## CITY OF NOVI CITY COUNCIL DECEMBER 15, 2025

**SUBJECT:** Consideration of the Fifth Amendment to the SDO Agreement for Cadillac of Novi, amended Preliminary Site Plan and Stormwater Management Plan.

# PLAN REVIEW CENTER REPORT

**Review Date:** July 16, 2025  
**Review Type:** Preliminary Site Plan  
**Project Name:** JSP25-07 Cadillac of Novi  
**Plan Date:** June 23, 2025  
**Prepared by:** Dan Commer, Planner  
**Contact:** **E-mail:** dcommer@cityofnovi.org **Phone:** 248.735.5607

SCALE: 1" = 60'  
SHEET NO. 0548  
C10

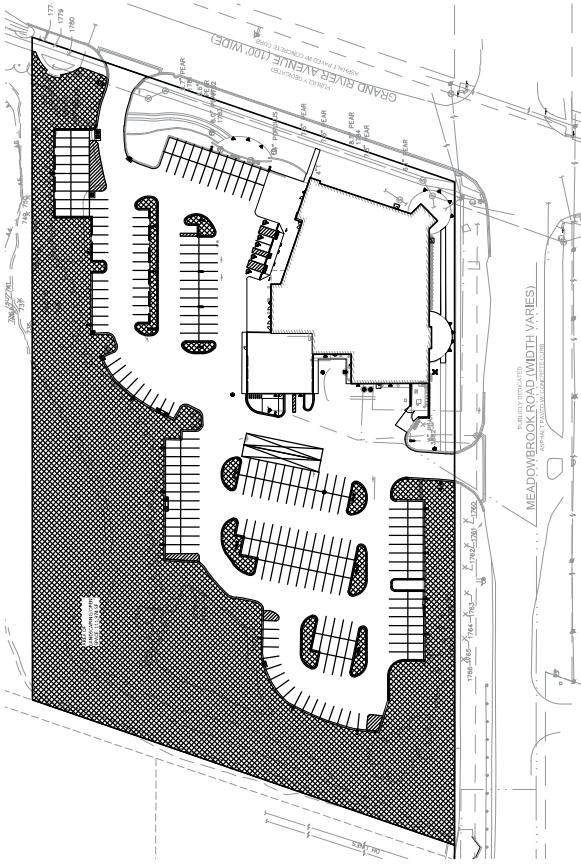
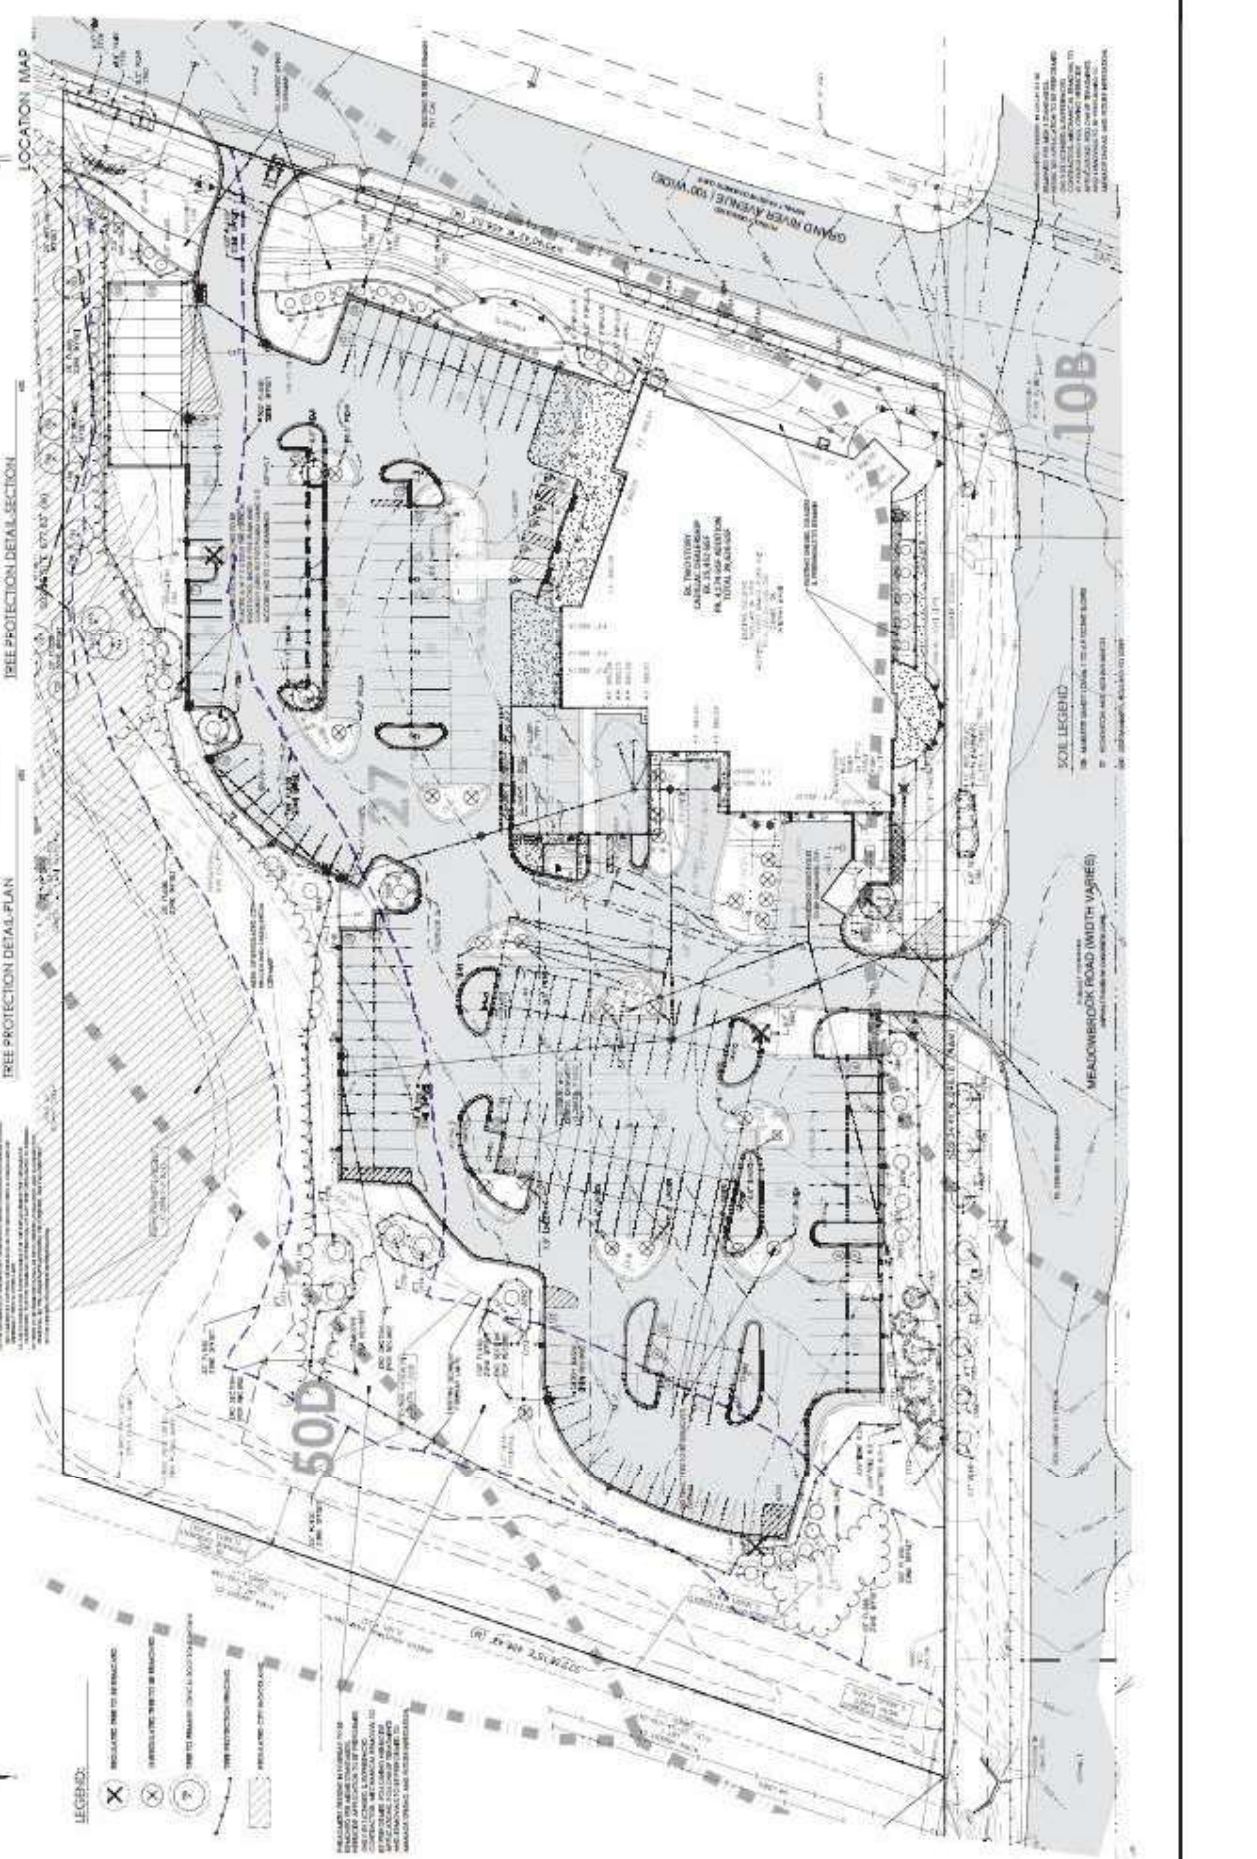
4. Open Space (Sec. 3.11.7): A minimum of 25% of the gross site area shall be left as open space. Open space areas and calculations have been provided on sheet C10, as requested, however, open spaces are still being miscalculated. **Refer to the Planning Review Chart for additional information on allowable percentages of open space categories and edit calculations to include areas along Grand River Avenue and Meadowbrook (see also example provided).**

EXTERIOR ELEVATIONS  
A2.1

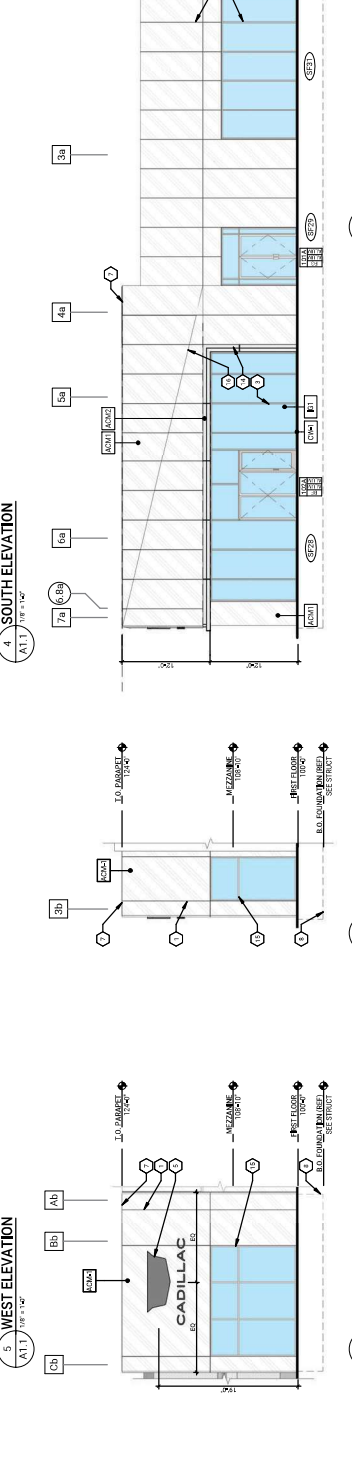
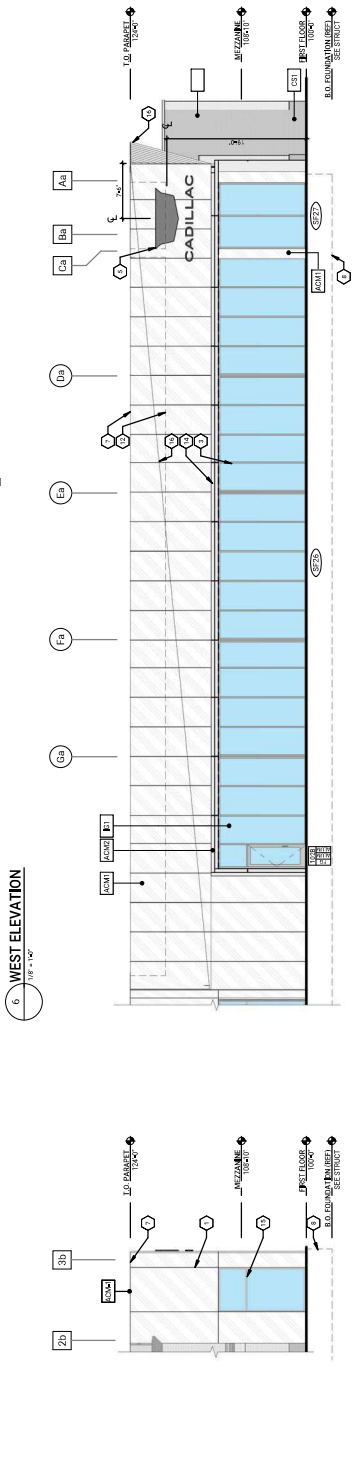
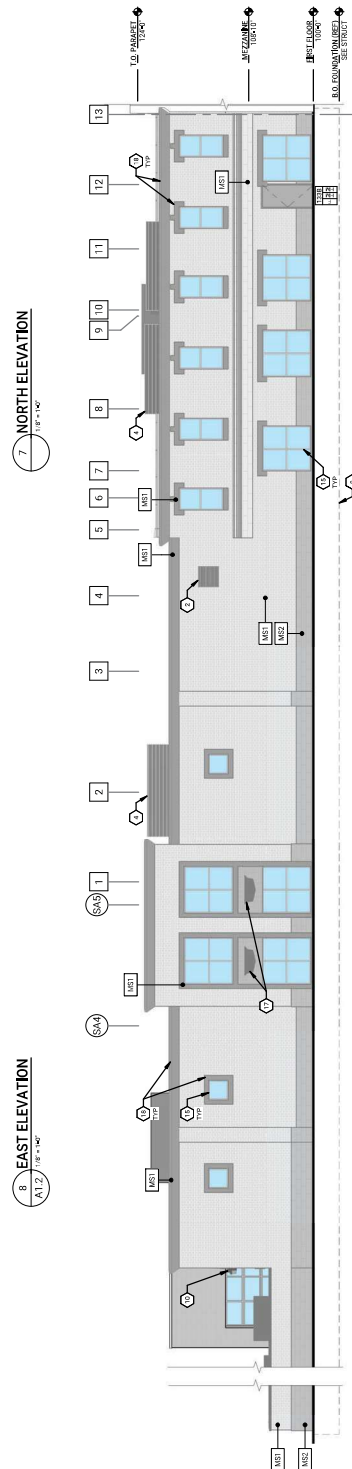
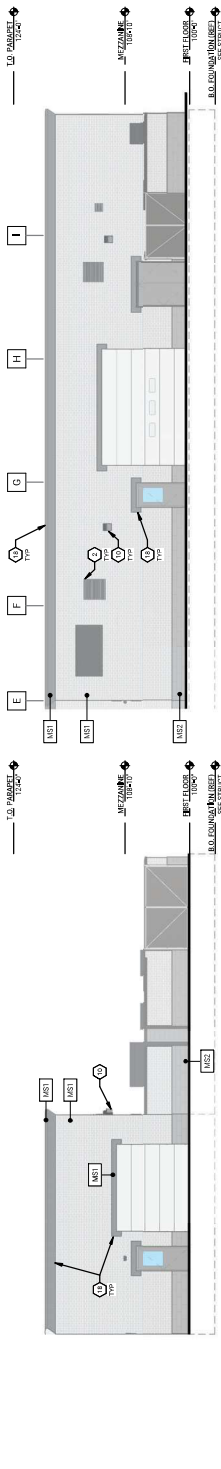
- c. Section 9 Façade waiver for an underage of brick on the South (front) facade of the high-visibility buildings (0% proposed, 30% required), and an overage of Flat Metal Panels on South (front) and East facades (100% proposed (South) and 51% proposed (East), 50% Maximum), *because the angled profile of the Flat Metal Panels will provide an interesting architectural effect that would not otherwise be enhanced by strict application of Façade Ordinance requirements.*

5. Building Façade and Scale (Sec. 3.11.8): Flat Metal Panels (ACM) are proposed for the front of building. A Section 9 Façade Waiver for use of the proposed Flat Metal Panels instead of the required Brick will require approval from City Council as part of a revised SDO agreement and is recommended for approval by the City's Façade Consultant.
